ORDINANCE NO. 19-11-35

AN ORDINANCE GRANTING A SPECIAL USE FOR A PLANNED UNIT DEVELOPMENT FOR THE SONDAY LIGHT INDUSTRIAL PARK LOCATED AT 453 N. MAIN STREET - (PZB 19-10 SPR/SU)

SUBJECT: REPORT TO VILLAGE BOARD

CASE: Sonday Industrial

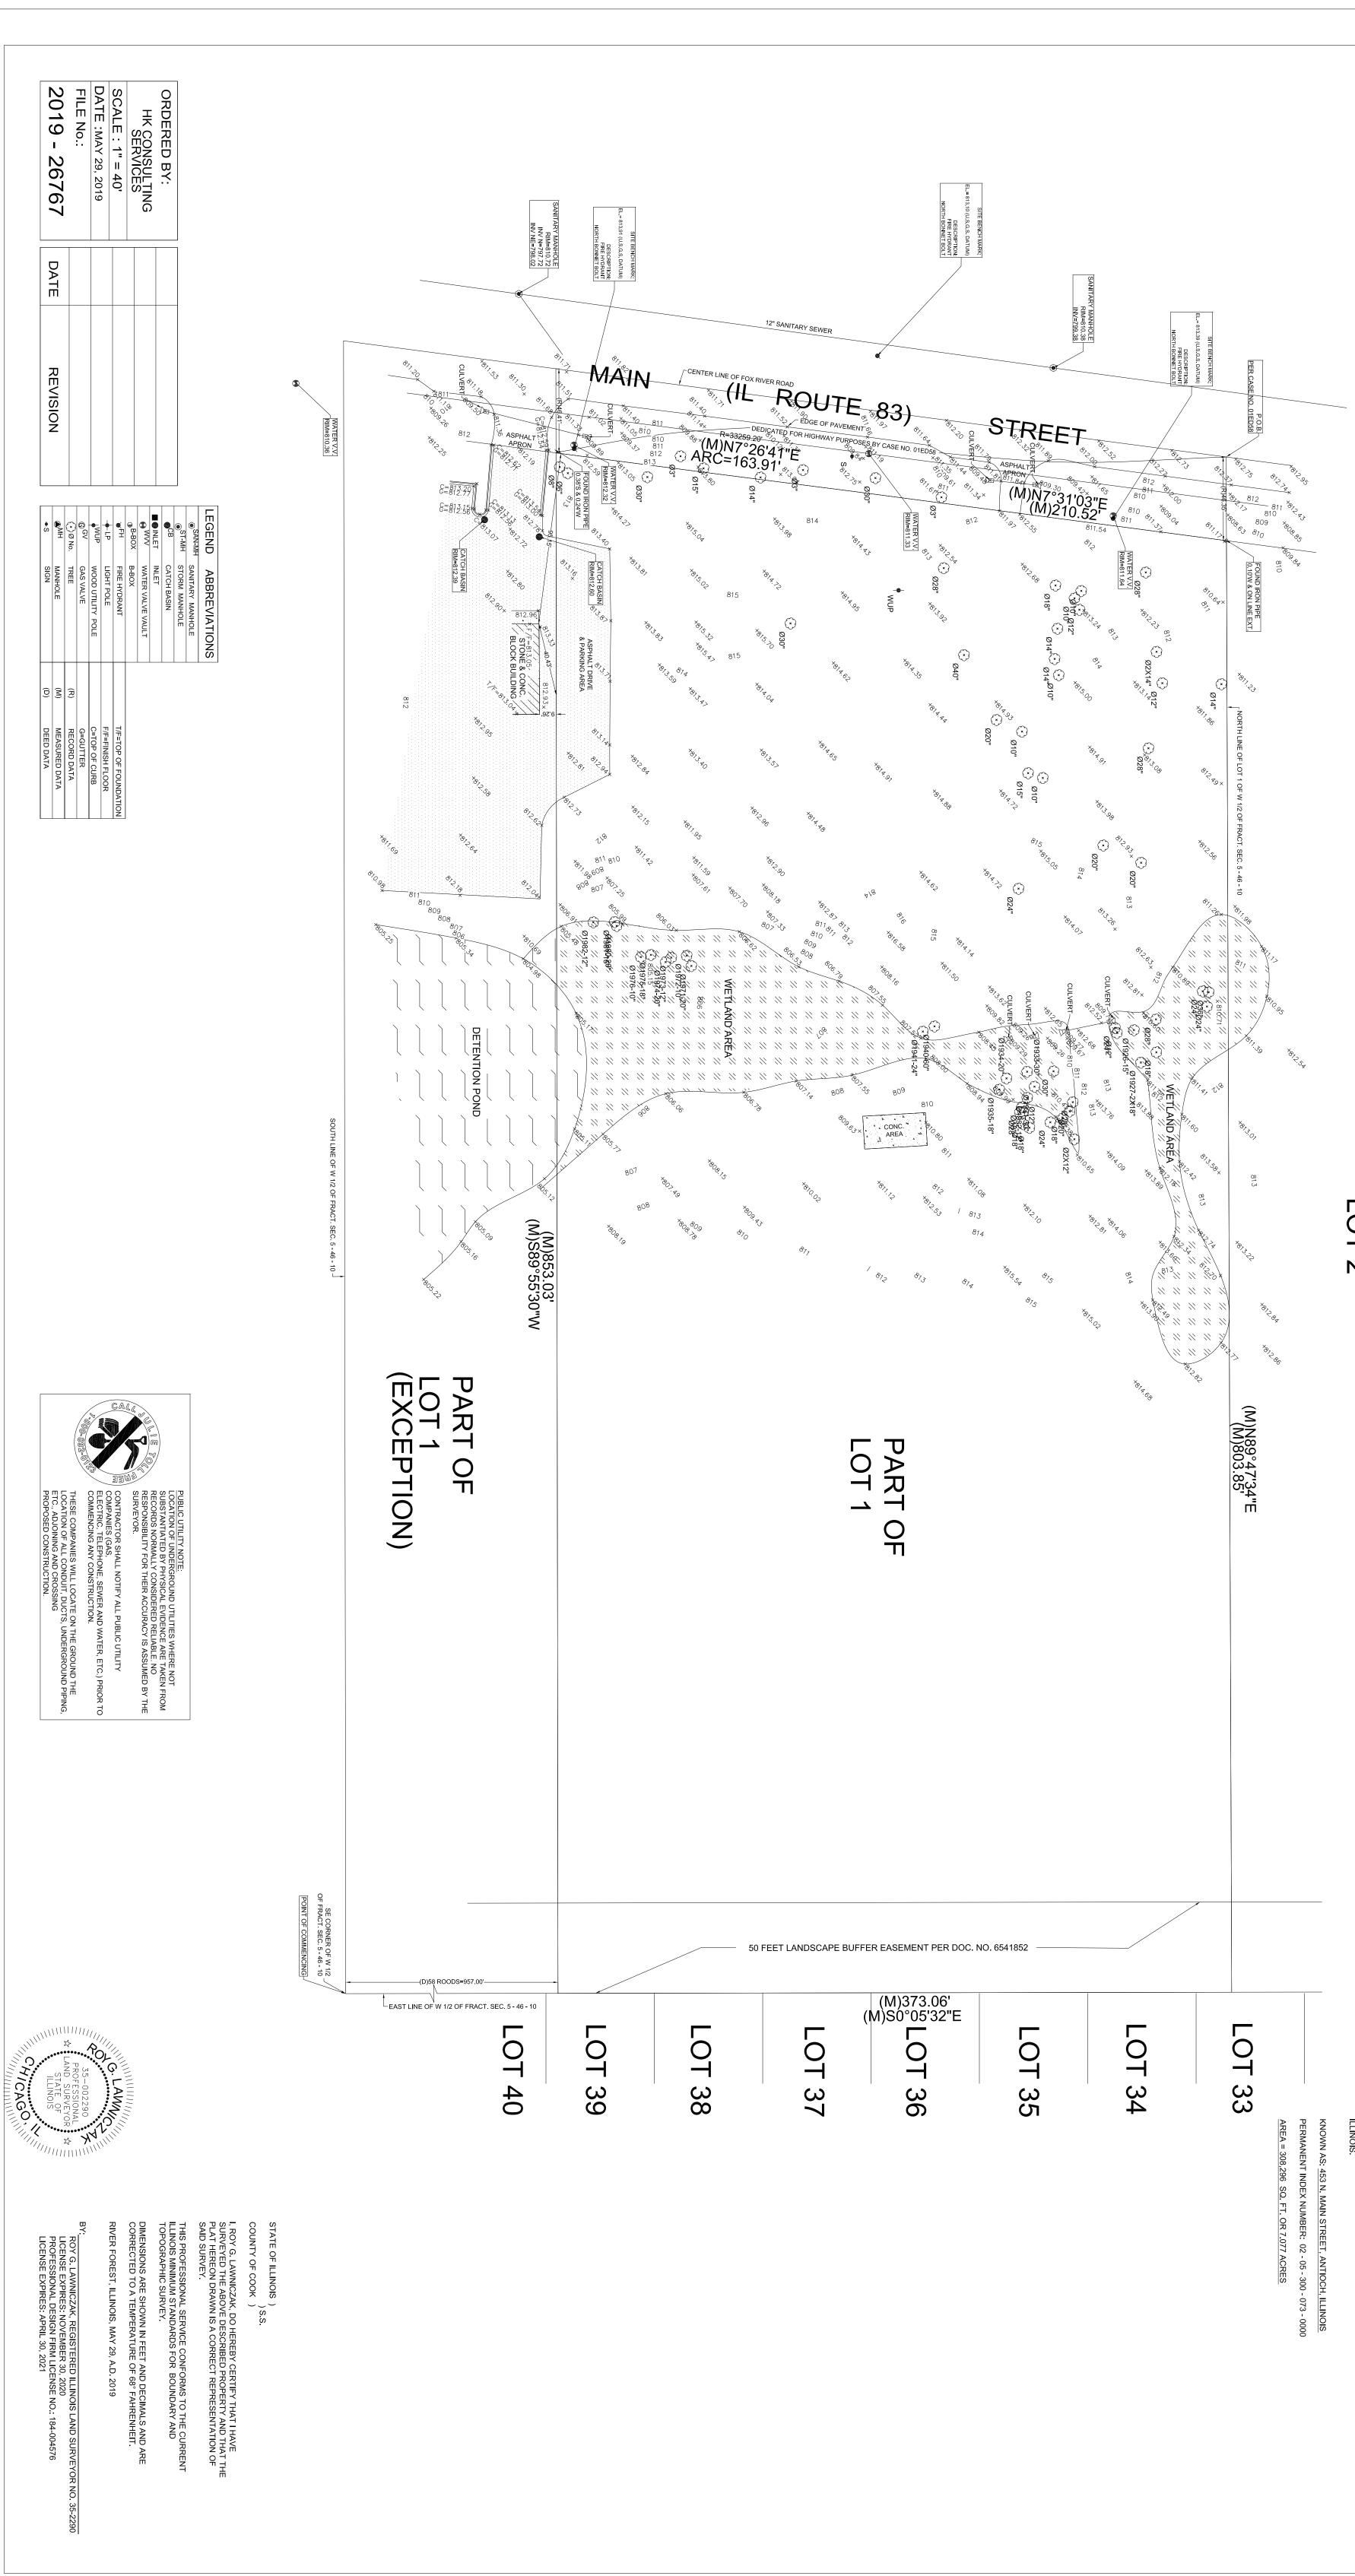
The applicant has submitted a photometric plan and Staff has had an opportunity to review the plan. The Village's Site Plan Review ordinance requires a maximum foot candle illumination level of 0.50 at the property line. The applicant's photometric plan conforms with this requirement. The applicant has submitted a lighting specification that conforms with the Village's ordinance.
